METROPOLITAN GOVERNMENT OF NASHVILLE AND DAVIDSON COUNTY

STAFF RECOMMENDATION
1304 4th Avenue North and 1309 3rd Avenue North
April 15, 2015

Application: New construction-infill
District: Germantown Historic Preservation Zoning Overlay
Council District: 19
Map and Parcel Number: 08209019300, 08209019800
Applicant: Price Development Group
Project Lead: Robin Zeigler, robin.zeigler@nashville.gov

2 SOUTH (MONROE ST.) ELEVATION
 SCALE 1/8" = 1'-0"

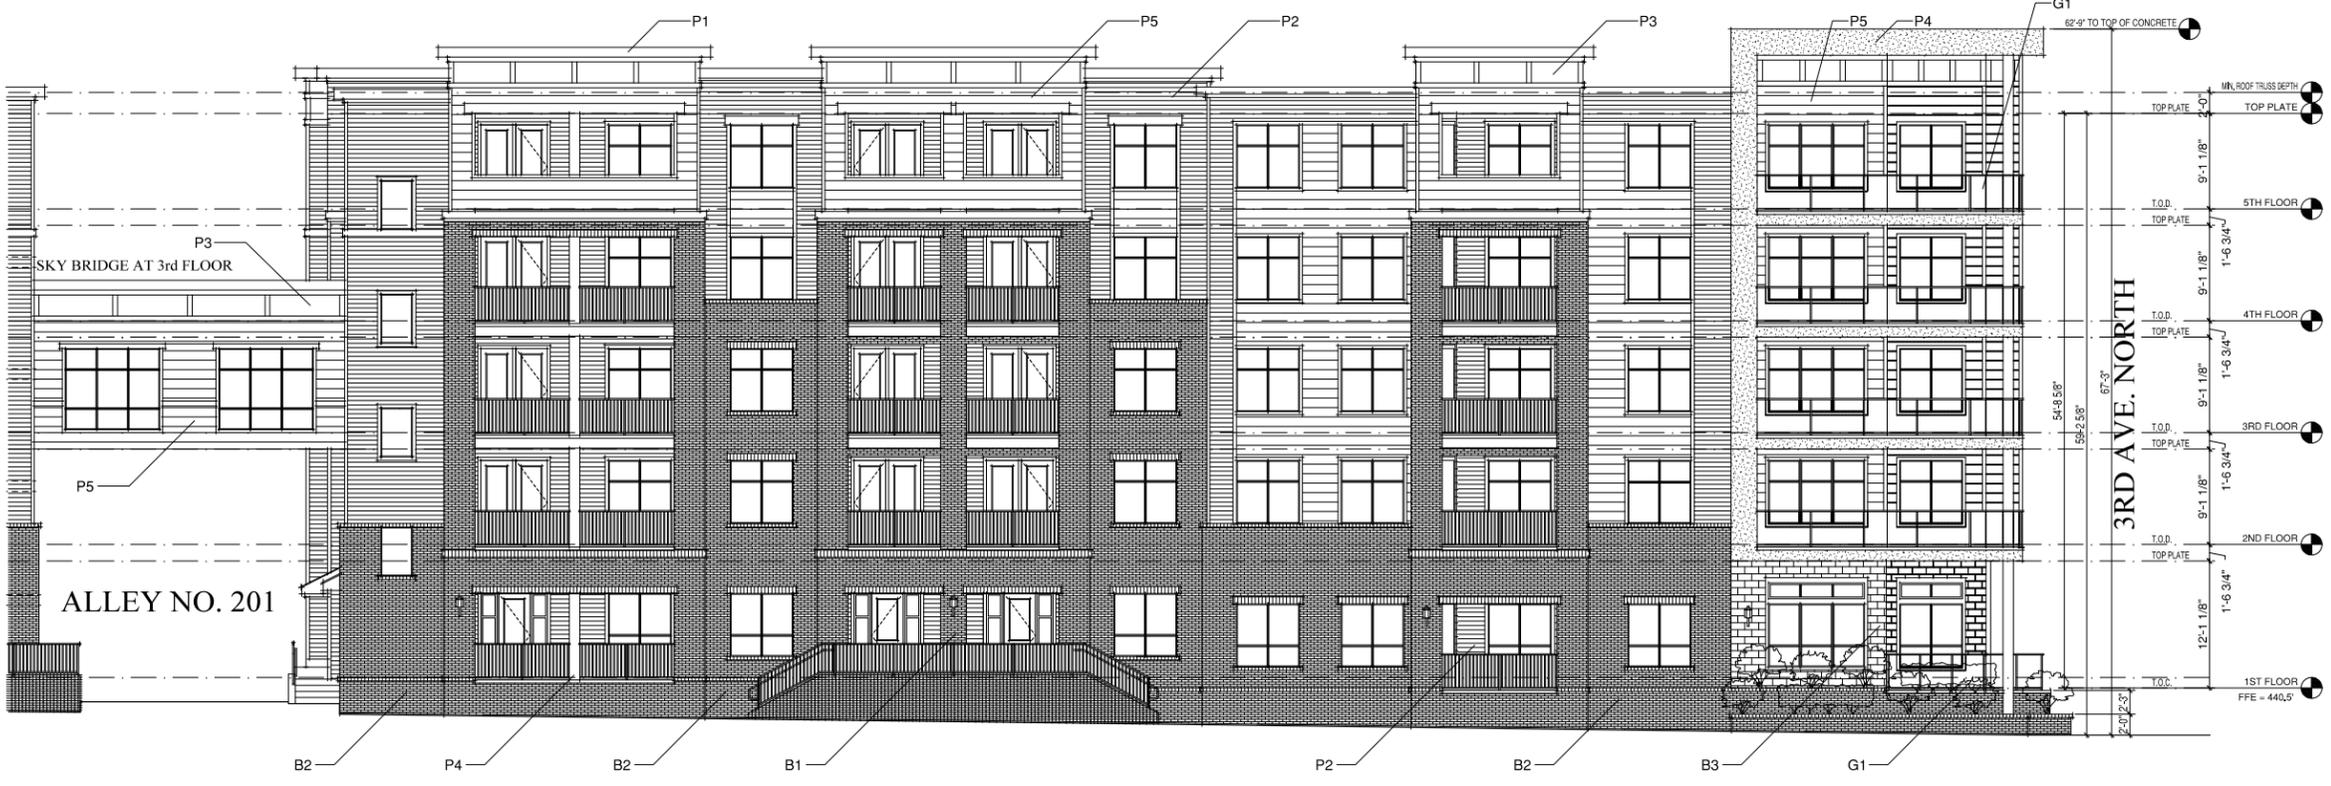
Height: The Commission approved a height of four stories for the corner of Monroe Street and Fourth Avenue at the November 2014 meeting. The current drawings show what amounts to a fifth story at the corner of Fourth Avenue North and Monroe Street. The applicant has agreed to lower this height and has added a note on page 13.

this will be dropped to be
 in line with the roof-line to
 north and east

2 WEST (4TH AVE.) ELEVATION
SCALE 1/8" = 1'-0"

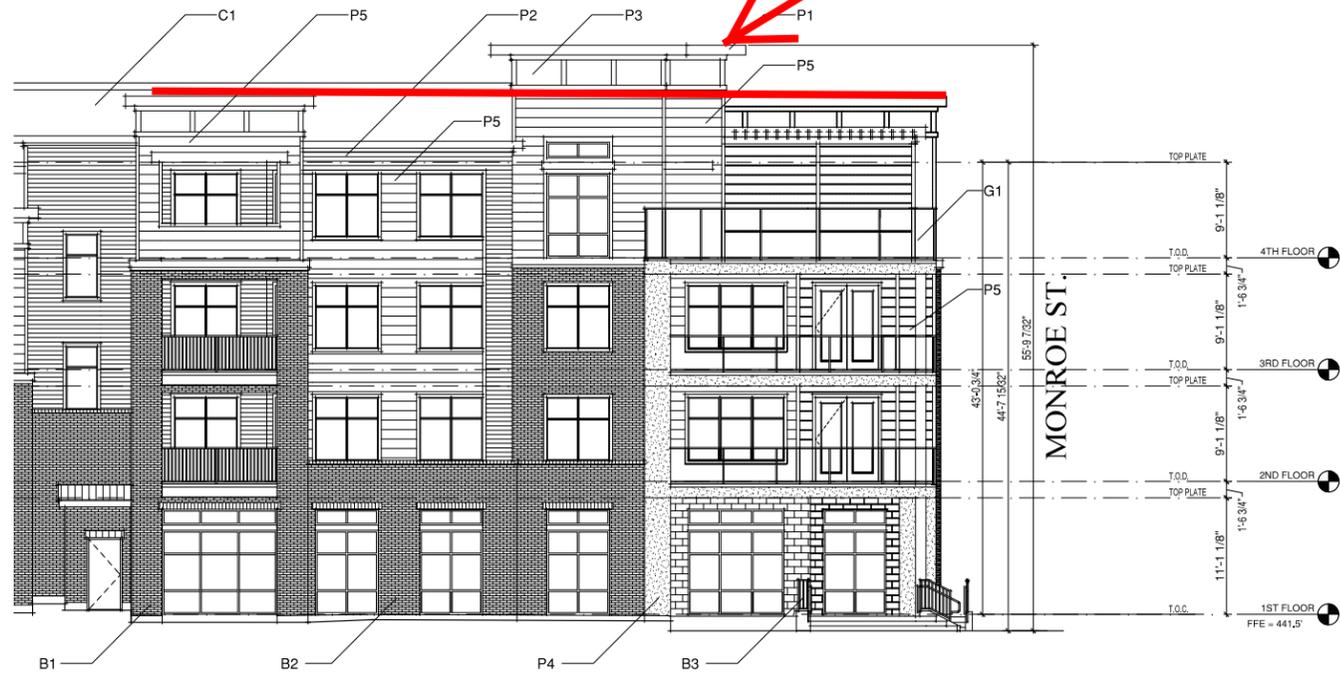
this will be dropped to be in line with the roof-line to north and east
